MEMORANDUM

RE: **Response to Peer Review Comments**
Fields 40B Residential Development
Sherborn, Massachusetts

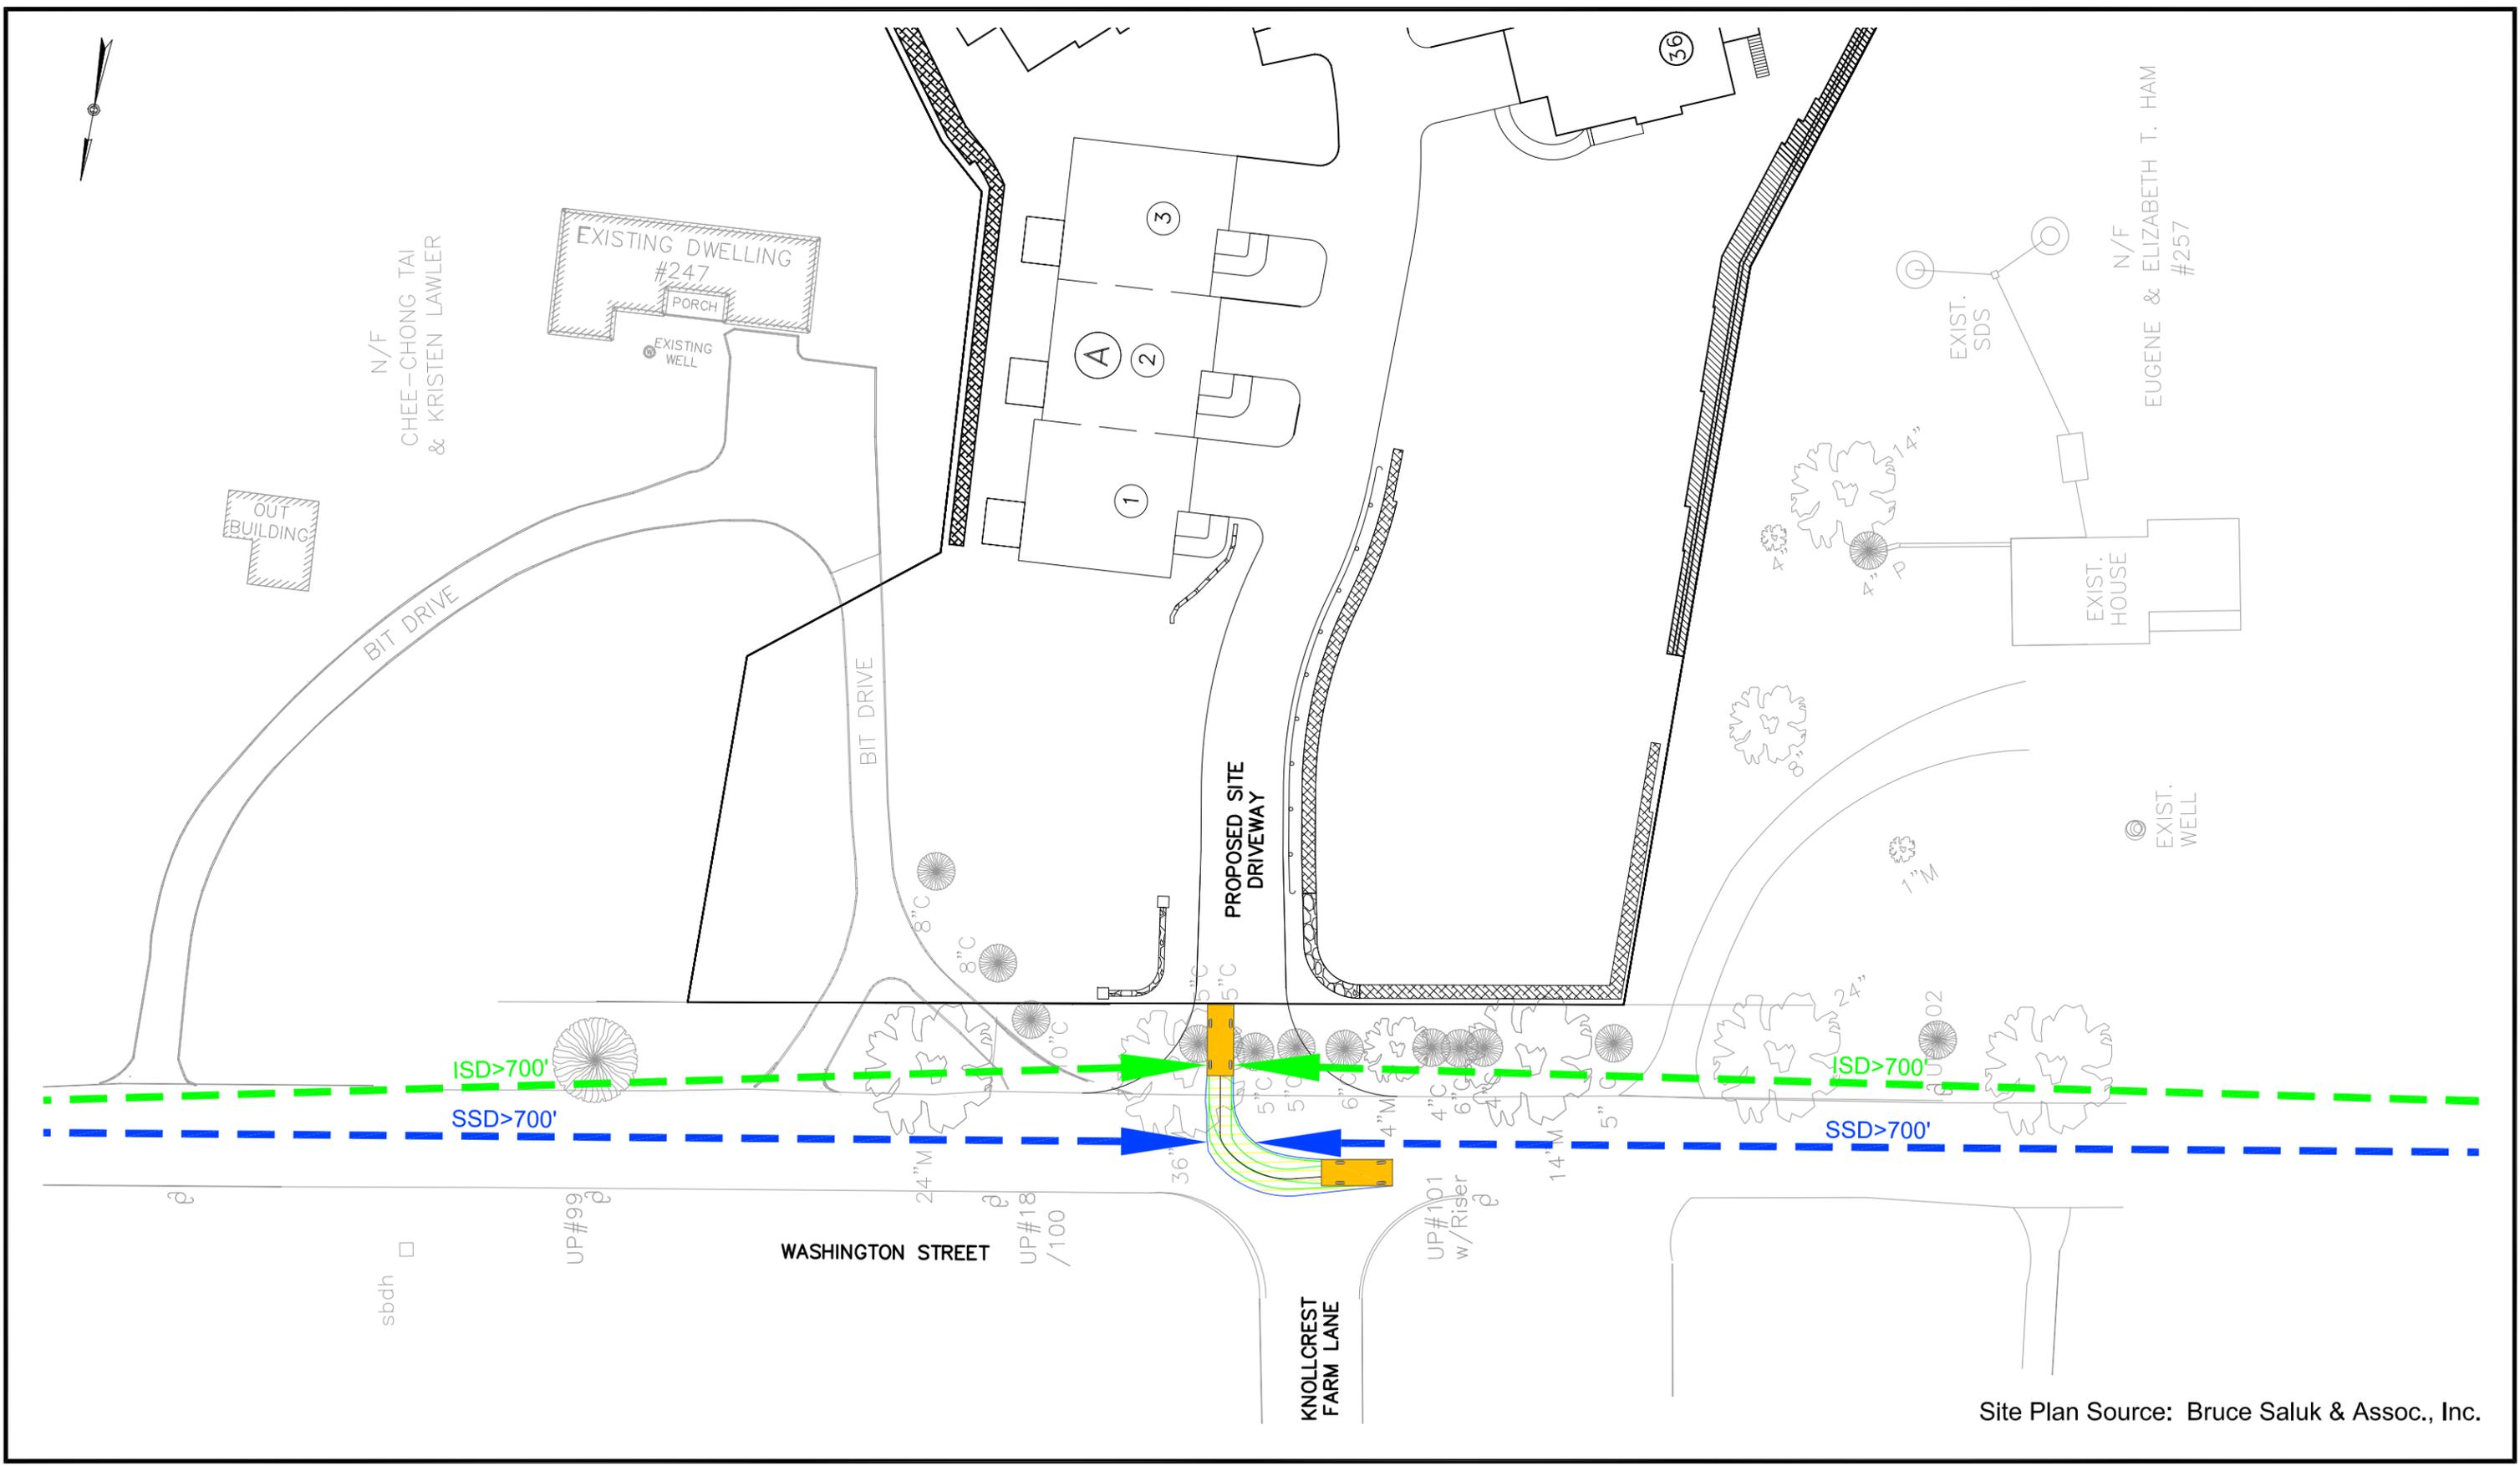
Comment T2: *"Indicate on plan where the intersection sight distance lines were measured...verify the height of the modular wall and that it will not impede the intersection sight distance."*

Response: Sight line measurements were conducted at two driveway locations: the roadway

travel edge in the case of stopping sight distance (SSD) and at a driver's eye position at a vehicle stopped position 8 feet back of travel way for intersection sight distance (ISD). A summary of the measured sight lines from these positions is illustrated in the attached **Exhibit 1**. Measurement of the ISD from the 8-foot distance from travel way represents the likely stopped position exiting the driveway and provides sufficient visibility to oncoming vehicles without having to remove mature vegetation. The resulting sight lines are also located beyond the view line of the proposed wall at the driveway.

Sherborn Engine 3

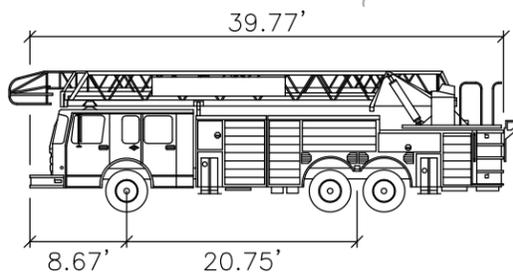
Comment T9: *“Provide an AutoTurn® plan to verify that there is an adequate turning radius for emergency vehicles maneuvering around the site.”*

Response: An Autoturn® vehicle turn analysis is presented in **Exhibit 2** for the Town’s largest responding vehicle (Engine 3, an aerial ladder truck), demonstrating that adequate roadway layout and curb radii are available to accommodate vehicle maneuvers.
